## ROSE SENIOR LIVING AT PROVIDENCE JSP13-81

Public hearing at the request of Edward Rose and Sons for recommendation to City Council for approval of a Planned Suburban Low-Rise (PSLR) Overlay Development Agreement Application and Concept Plan. The subject property is 23.61 acres in Section 17 of the City of Novi and located on the north side of Eleven Mile Road and west of Beck Road. The applicant is proposing a 182 unit senior living facility.

# PLAN REVIEW CENTER REPORT

FIGURE 6A: PROPOSE CARPORTS IN THE INTERIOR SIDE YARD (SOUTHWEST)

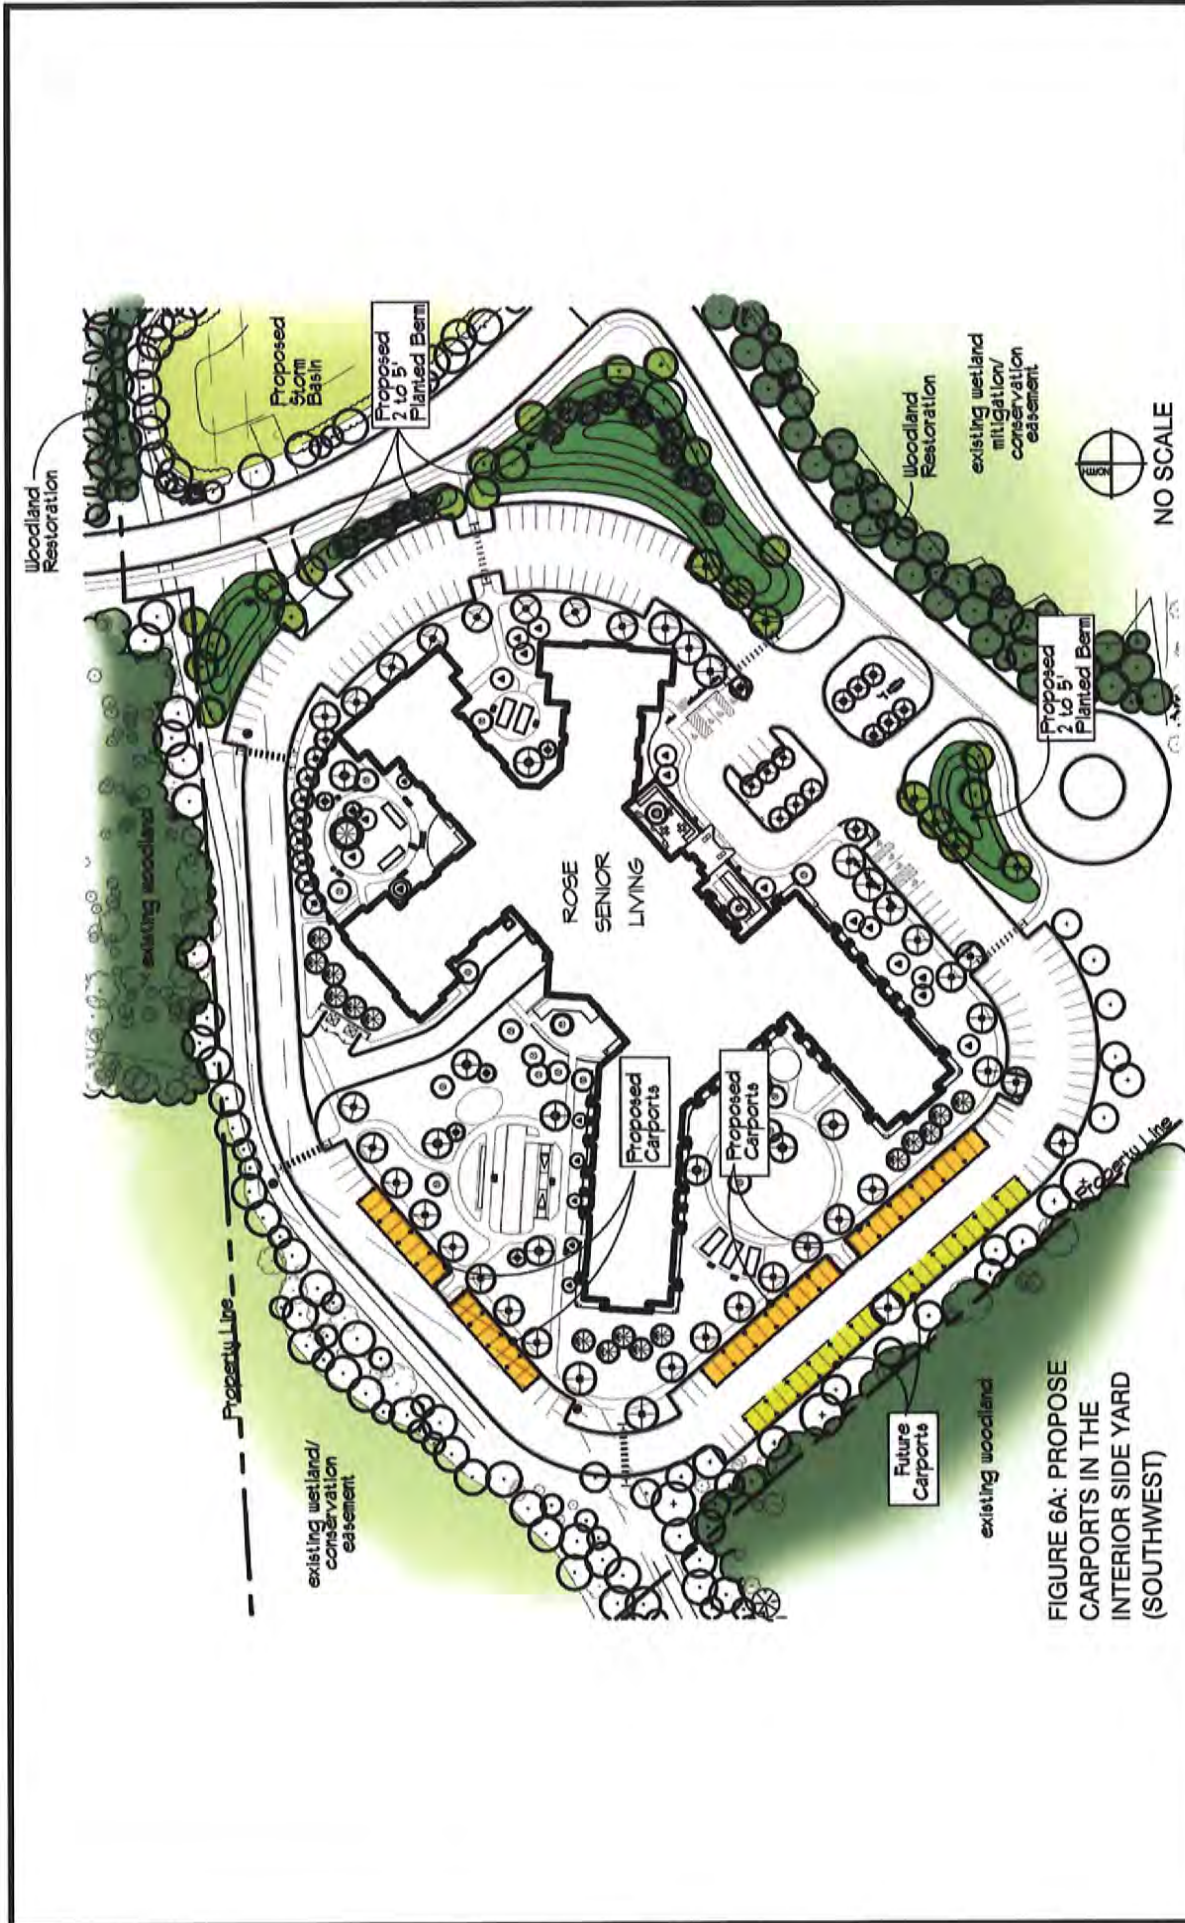
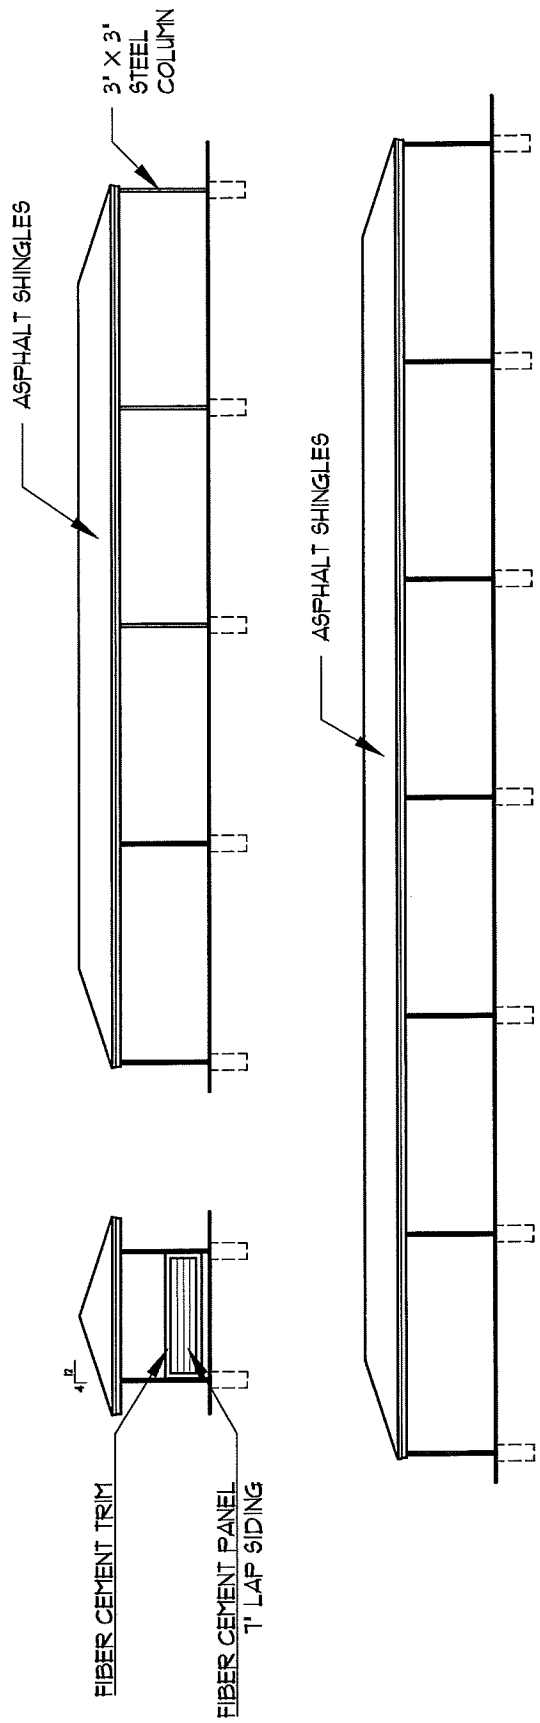
**Narrative:** Carports meet required setbacks and are buffered from adjacent properties and roads by natural features such as wooded wetlands, woodlands, and screened by 2 to 5 foot tall berms planted with both evergreen and deciduous canopy trees.

**Graphic Depiction:** Figure 6A and 6B attached and detail 3 on sheet A3.5 and sheet L302 show a graphical depiction of the carports proposed in the interior side yard (southwest) and illustrate the elements described in the narrative.

FIGURE 7A:  
PROPOSE TWO  
ON-PREMISE SIGNS

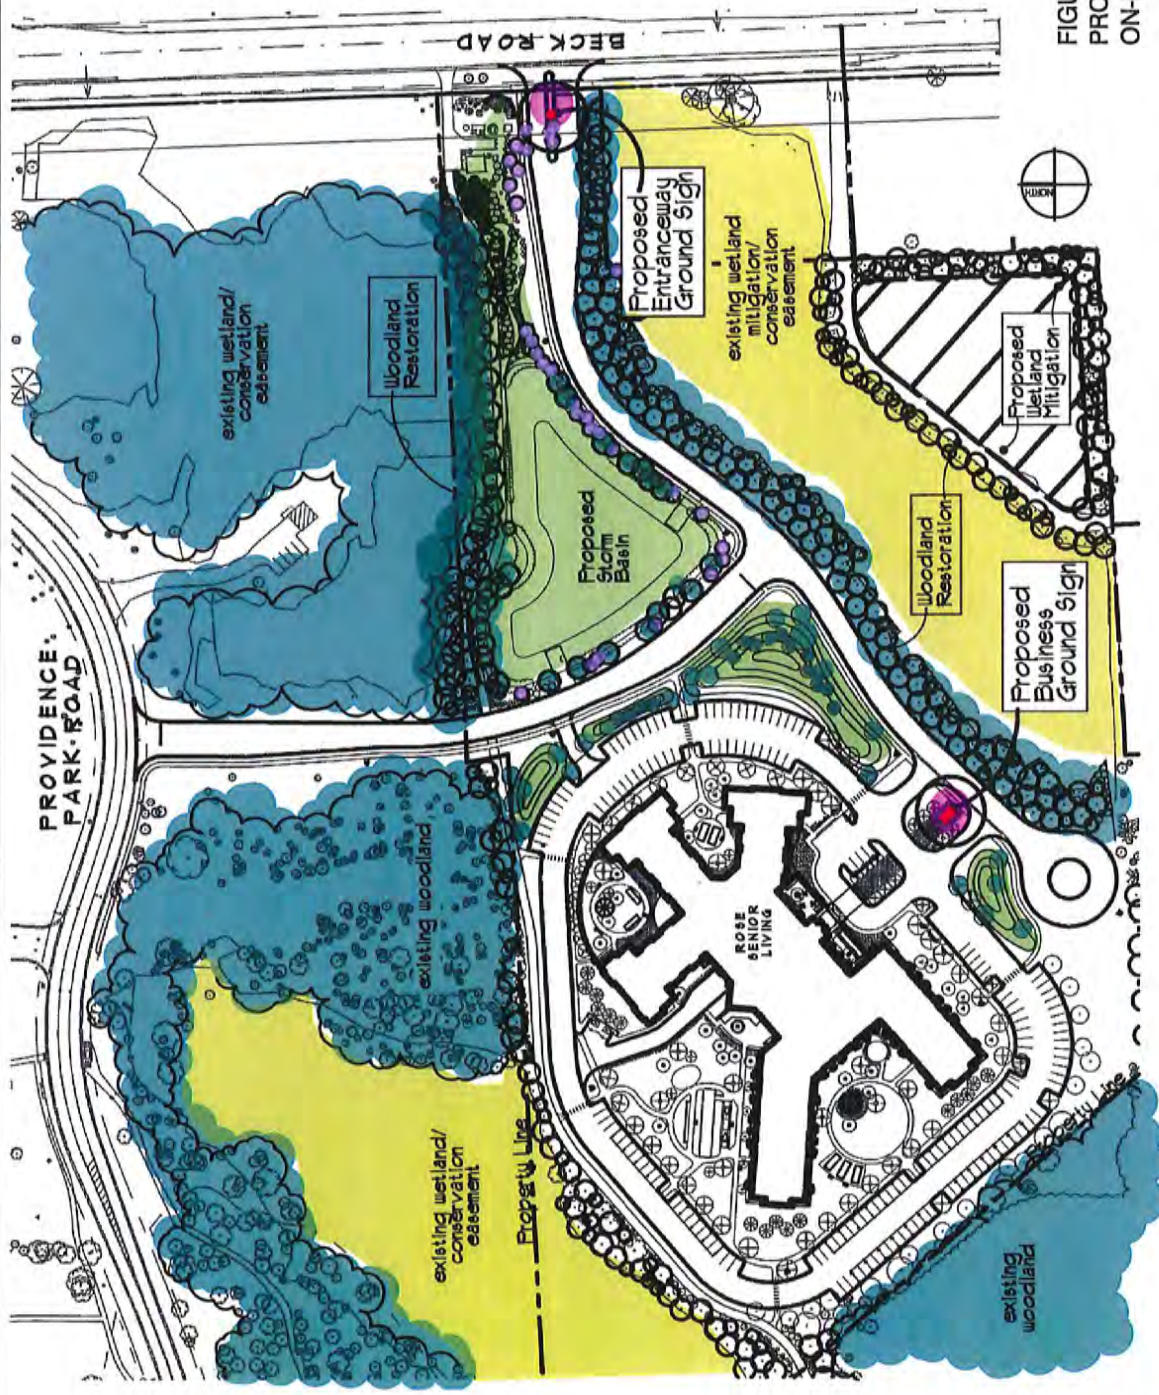
**Narrative:** Due to the long distance from the proposed advertising/ground sign located at the senior living building to Beck Rd. (600 feet) and Providence Park Dr. (680 feet) in addition to the amount of existing and proposed natural features (wetlands, woodlands, storm basin, berms, plantings, etc.) the applicant requests to provide one additional sign (entranceway) to clearly announce, identify, and provide direction to the senior living community's entrance.

**Graphic Depiction:** Figure 7A and 7B attached and plan sheet L402 show a graphical depiction of the proposed signage and illustrate the elements described in the narrative.

FIGURE 10: PROPOSED DOWNWARD SLOPE AWAY FROM ROAD

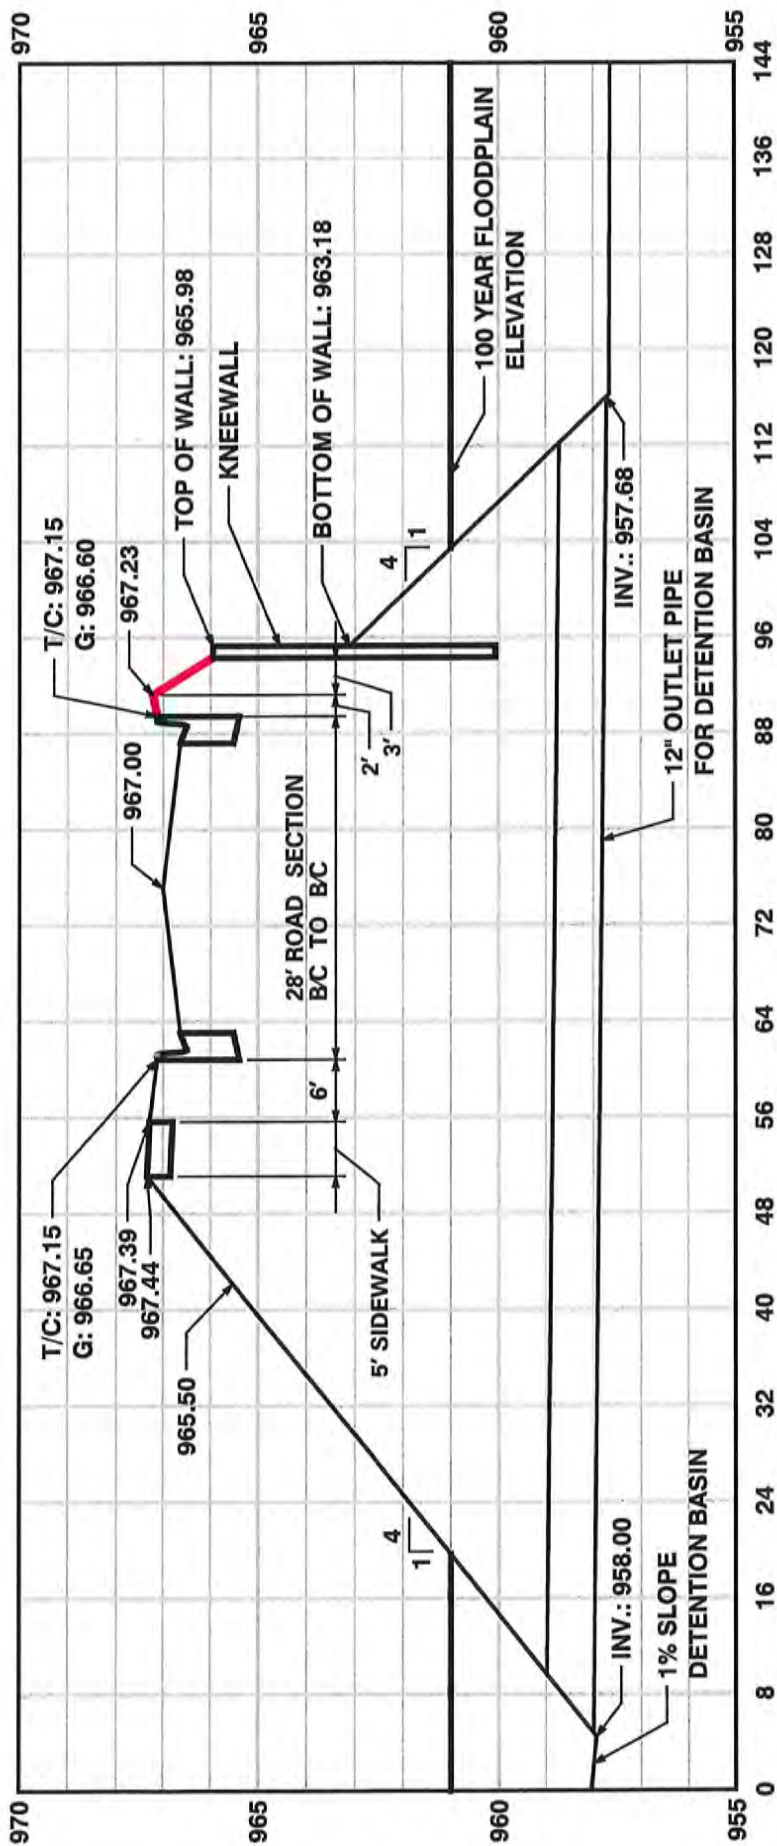
**Narrative:** The proposed grading plan provides a downward slope away from the proposed roadway that drains into existing mitigated wetland areas on portions of the proposed roadway to minimize impacts to natural features. As a knee wall is required to make the transition between the roadway elevations required and the existing mitigated wetlands to the south of the proposed roadway, the need to minimize the height of the wall and allow the proposed roadway to blend better back to the existing conditions is necessary.

**Graphic Depiction:** Figure 10 attached and plan sheets C07 and C08 show a graphical depiction of the proposed roadway cross-section and illustrate the elements described in the narrative.

WAIVER 1A: PROPOSE 2' HT. TO 5' HT. UNDULATING BERM TO SCREEN OFF-STREET PARKING WITHIN FRONT AND EXTERIOR SIDE SETBACK AREAS

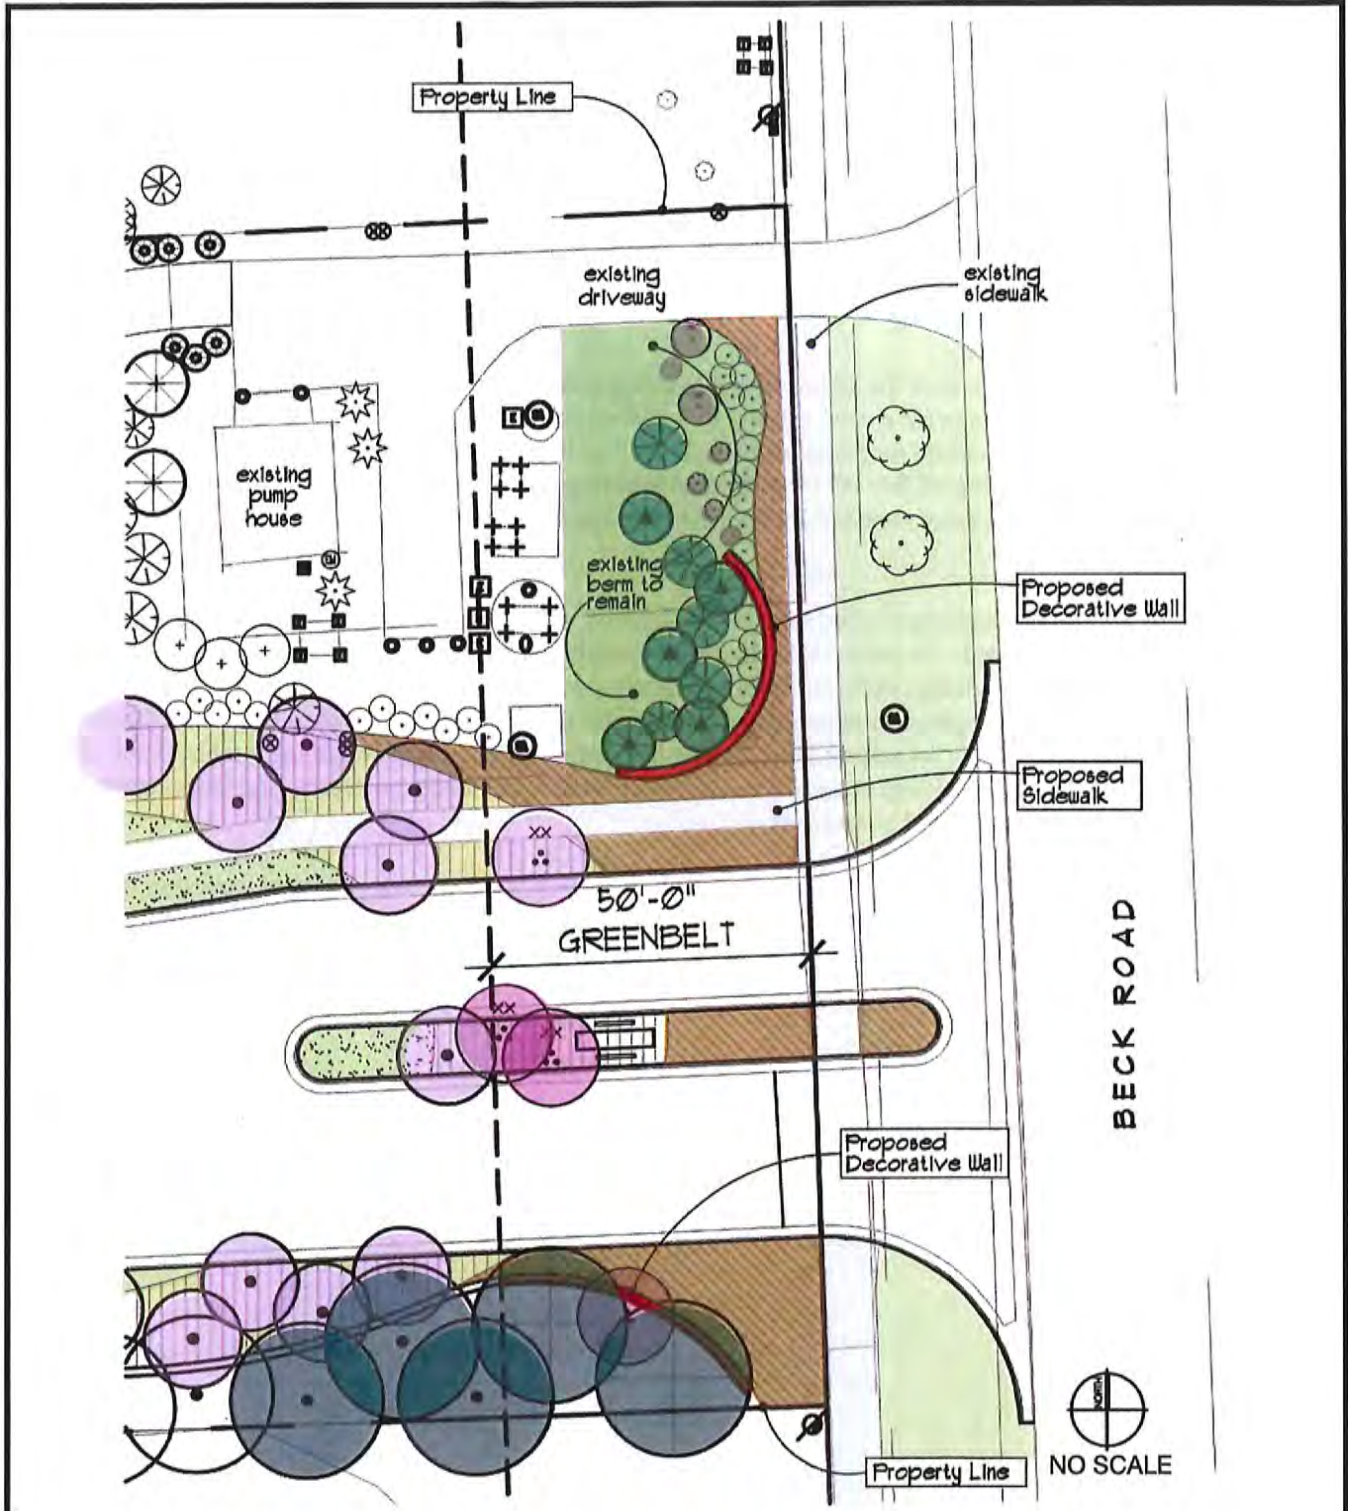
- A. A 2 to 5 foot tall undulating berm between the proposed parking area and the proposed road.
- B. A 1.5 foot tall min. to 4 FT tall max. decorative wall fronting Beck Rd. in lieu of the required berm along the frontage.

Graphic Depiction: Figure “Waiver 1A” and “Waiver 1B” attached and plan sheet L201 show a graphical depiction of the proposed berms and decorative wall that illustrate the elements described in the narrative.
